Project No. 752019

February 4, 2020

Subject: Canaan Elementary School Roof

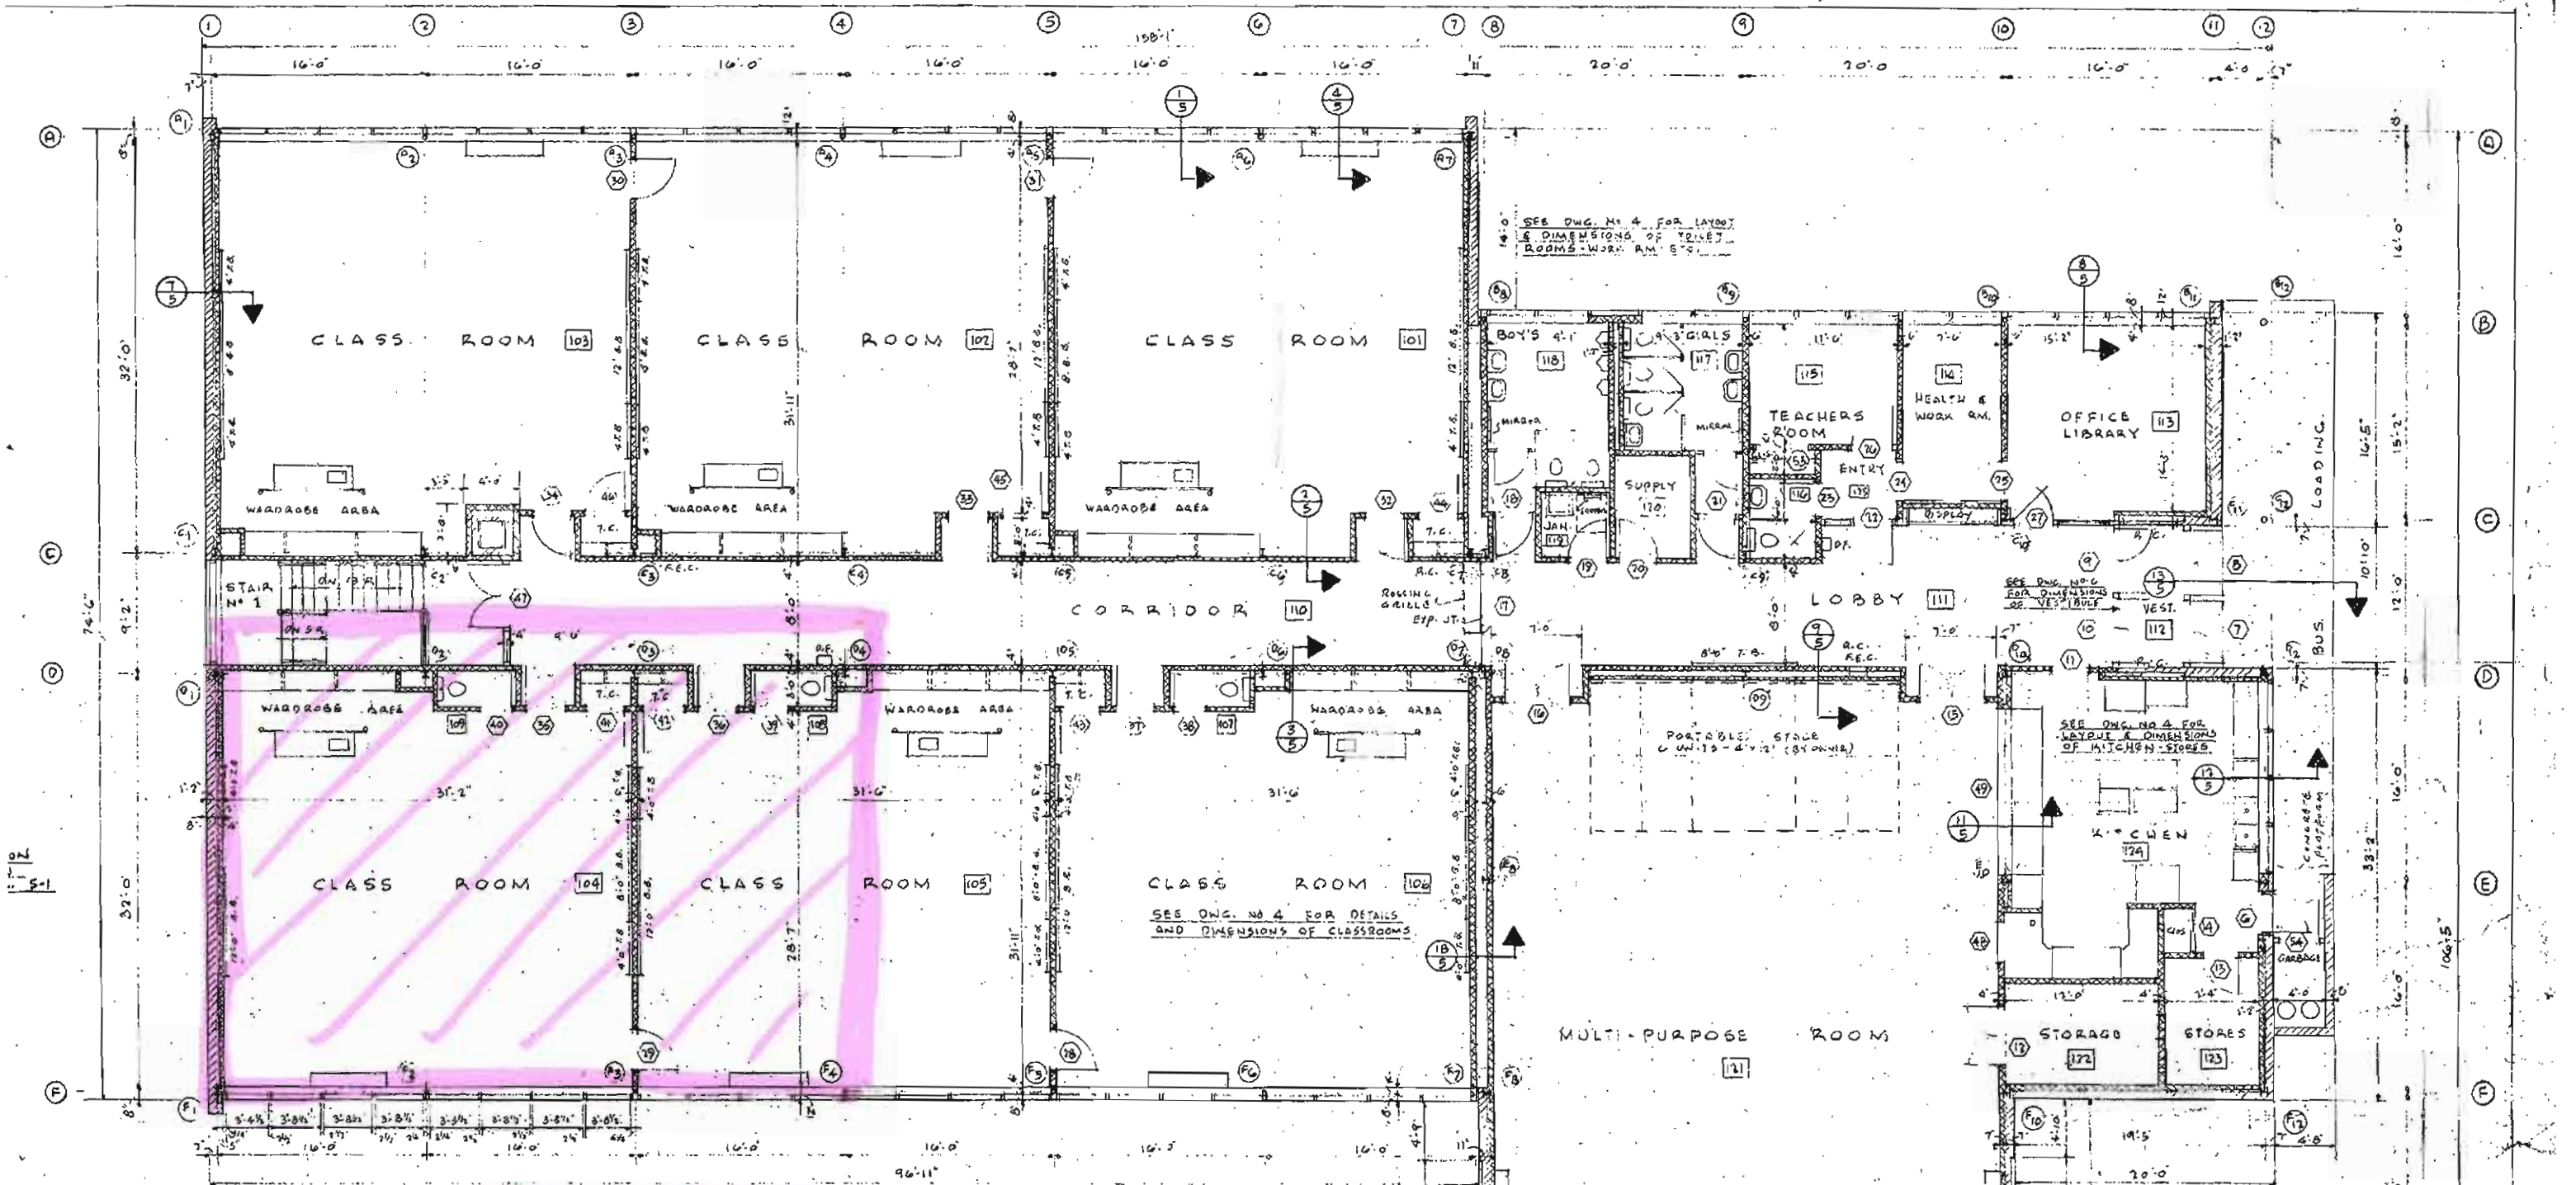
Looking northeast in attic space in southeast quadrant of school, above classroom wing. Track (arrows) at top of light gage cold formed studs is unreinforced and deformed.

Looking east in attic space in southeast quadrant of school, above classroom wing. Tracks at top of light gage cold formed stud walls are unreinforced and deformed.

Looking south in attic space in southeast quadrant of school, above classroom wing. Tracks at top of light gage cold formed stud walls are unreinforced and deformed.

Closer view of deformed tracks at top of studs. Note gap (arrow) between underside of standing seam roofing and top of track.

**EXCERPT FROM 1960 BUILDING PLANS SHOWING
CURRENTLY KNOWN PROBLEM AREA HATCHED**

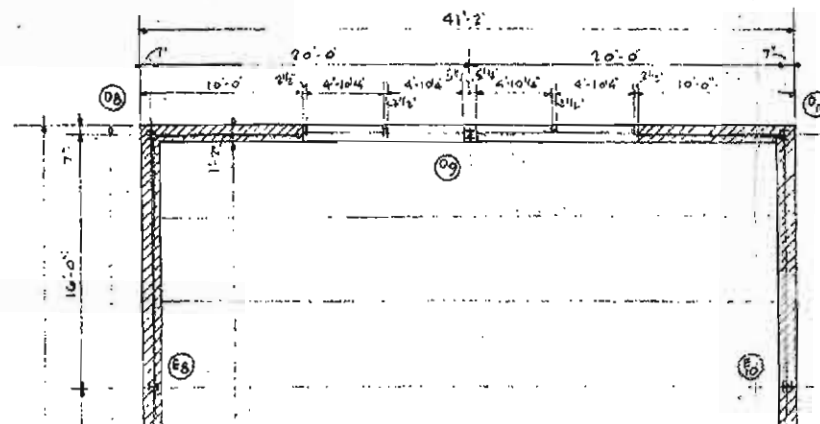
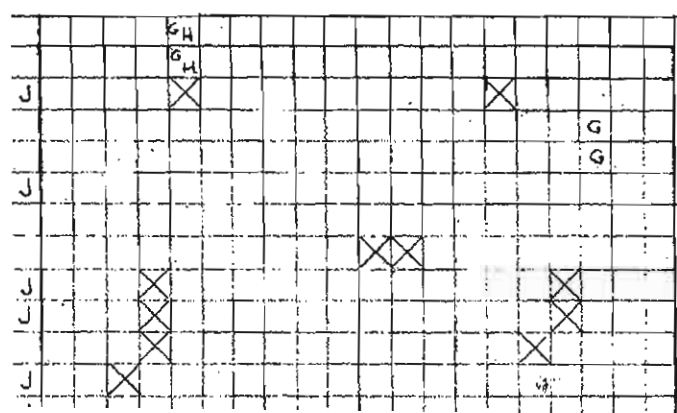
PROBLEM AREA
 236' x 50'

SK-1

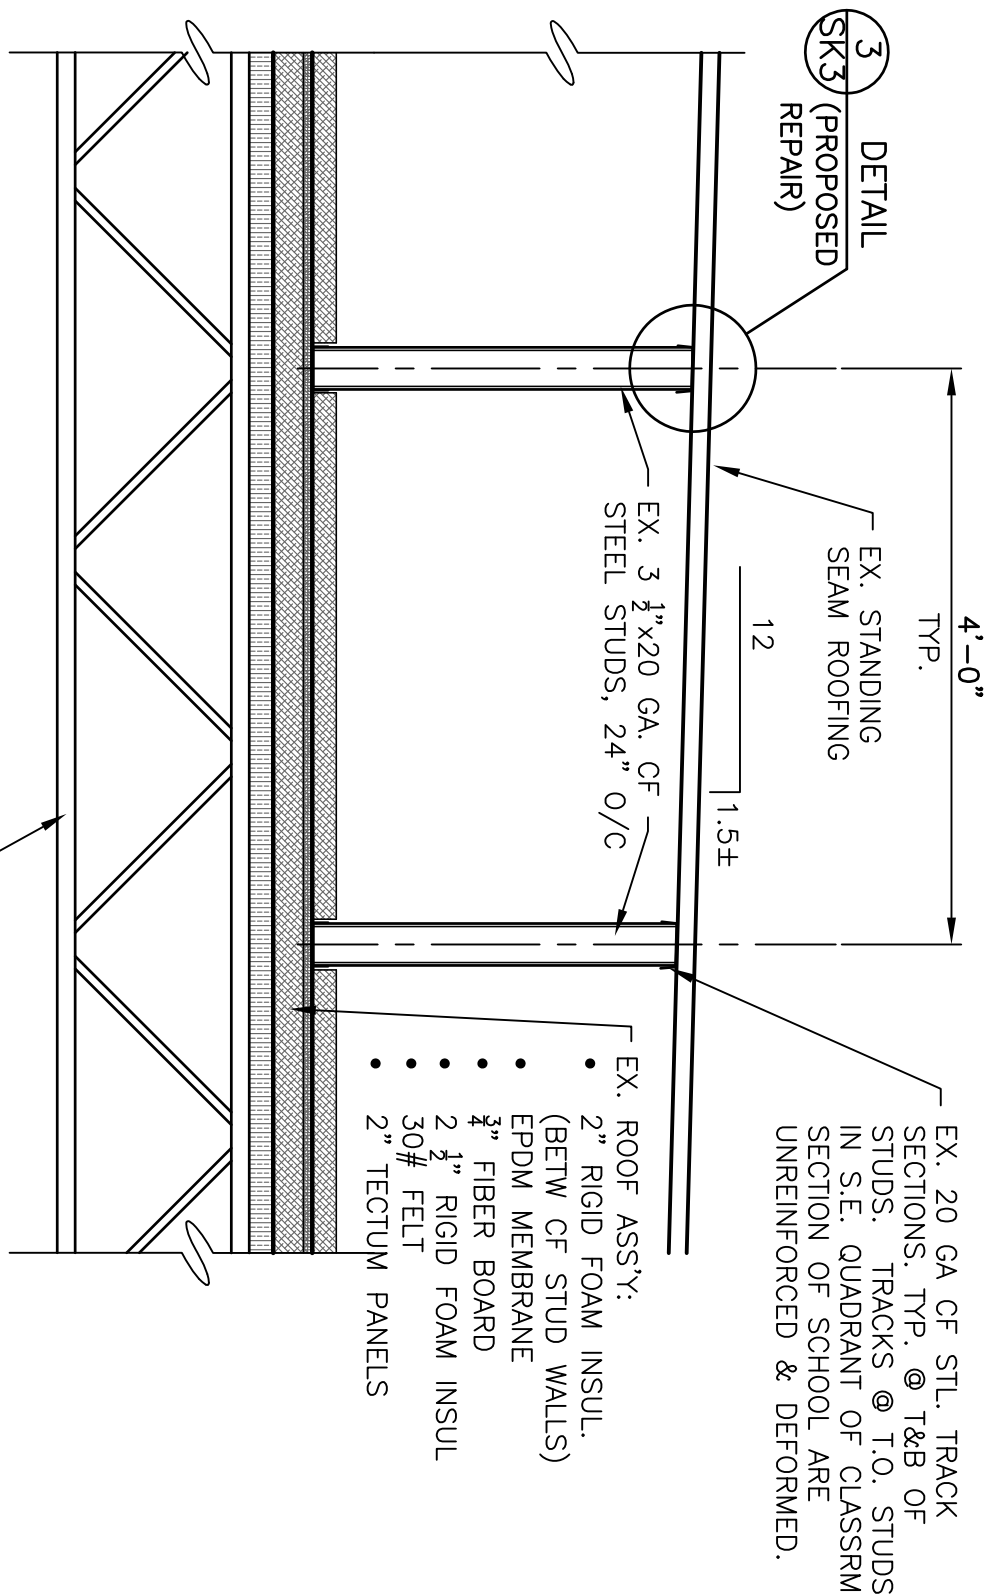
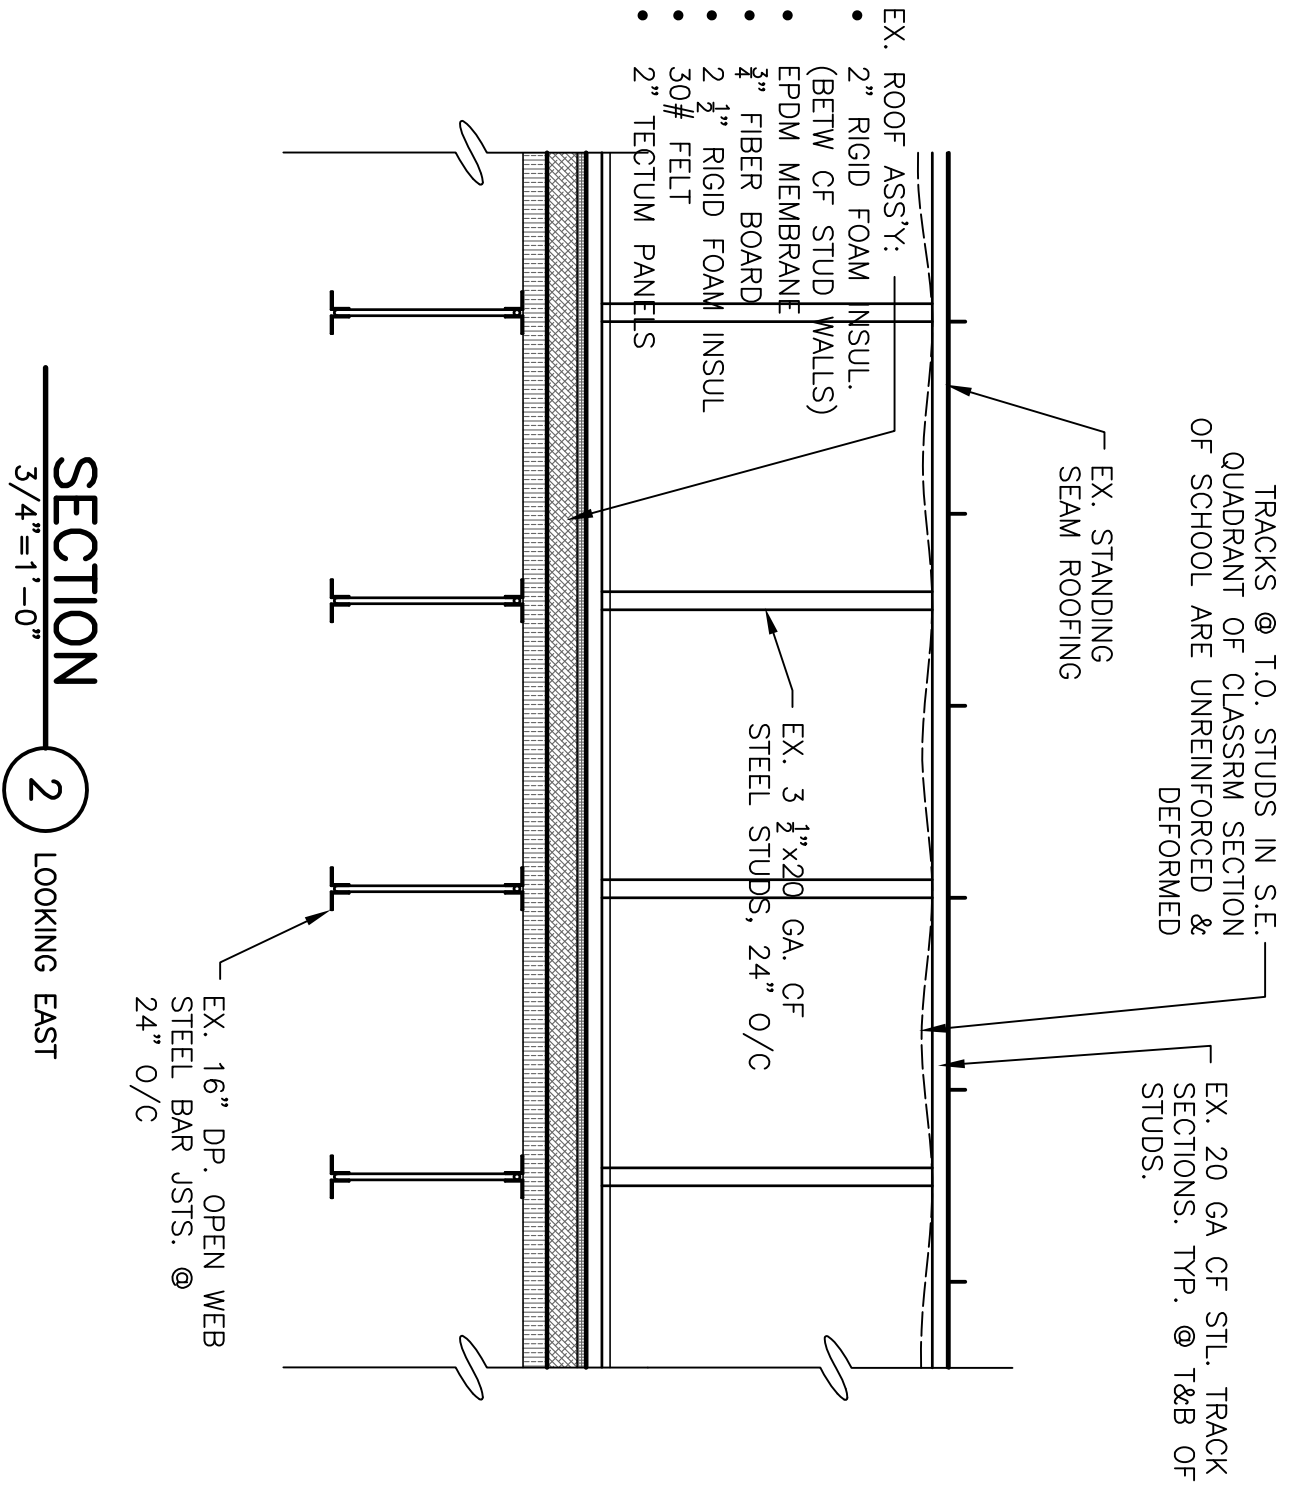
EX. 20 GA CF STL.
 UNREINFORCED &
 DEFORMED TRACK
 SECTION.
 EX. 3 1/2"x20 GA. CF
 STEEL STUDS, 24" O/C

TYP. @ ALL ROWS OF
 CF STL STUDS WHERE
 TRACK IS UNREINFORCED
 AND DEFORMED.

NOTE
 LOCATE NEW CF STL CSJ SECTION
 JUST UNDERNEATH LOW PTS. OF
 DEFORMED TRACK FLANGE TO ALLOW
 SUFFICIENT ROOM FOR P.T. WOOD
 SHIM AND MIN 1/2" NS GROUT.
 SD9112 SCREW TIPS HAVE MIN 1/4"
 CLEARANCE TO U'SIDE OF EX.
 ROOFING.

3 5/8" x 1 5/8" 20 GA CF STL CSJ
 SECTION 33 KSI FY. SCREW TO EA.
 EX. CF STL STUD W/ (3) #10 TEKS2
 SDST SCREWS. SEE NOTE

CEMENT/SAND DRY PACK GROUT SHIM.
 THKNS VARIES. MIN 1/2".
 CONT. P.T. WOOD SHIM 1 1/4"Hx1 1/2"W
 SEE NOTE.
 SIMPSON SD9112 (#9x1 1/2") SCREWS
 @ 8" O/C. PRE DRILL HOLES IN
 FLANGE OF NEW CSJ PRIOR TO
 INSTALLING. TIP OF SCREW PROTRUDES
 FROM PT WOOD SHIM TO HOLD GROUT
